UNITED STATES PATENT AND TRADEMARK OFFICE

APPLICATION NO.	FILING DATE	FIRST NAMED INVENTOR	ATTORNEY DOCKET NO.	CONFIRMATION NO.
10/689,001	10/20/2003	Gayatri Vyas	8540G-236COA	4101

Office Action Summary

DETAILED ACTION

F I G. 2

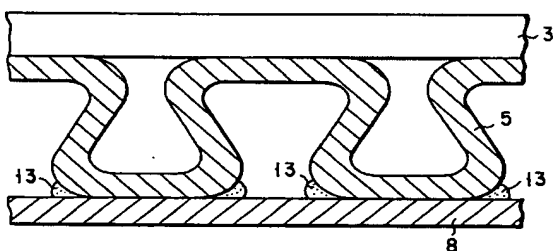
Tateishi et al divulge a fuel cell provided with an oxidizing gas side-collector plate (*the electrically conductive contact element facing the electrode*) having on it surface a composite oxide layer excellent in electric conductivity and corrosion resistance (ABSTRACT/ CLAIM 1). The collector plate disposed on the cathode side and comprises a main body made of SS, an Fe-Cr-Ni based alloy layer covering surface thereof; and a nickel-ferrite based composite oxide layer formed on a surface of the Fe-Cr-Ni alloy layer (ABSTRACT/ CLAIM 1).

Figure 2 below illustrates cathode 3, the specified collector plate 5 and interconnect 8:

Collector plate 5 serves to feed gas therethrough (COL 8, lines 65-67/ See FIGURE 2).

F I G. 2

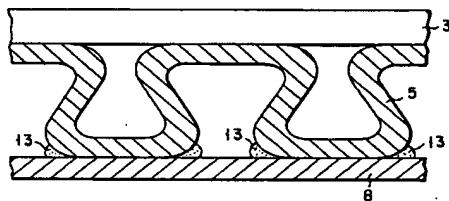
Collector plate 5 serves to feed gas therethrough (COL 8, lines 65-67/ See FIGURE 2).

Figure 2 depicts collector plate 5 having first and second fluid distribution surfaces (opposed surfaces). This configuration encompasses distributing grooves (open spaces) and lands (surfaces contacting cathode 3 and/or interconnect 8)..
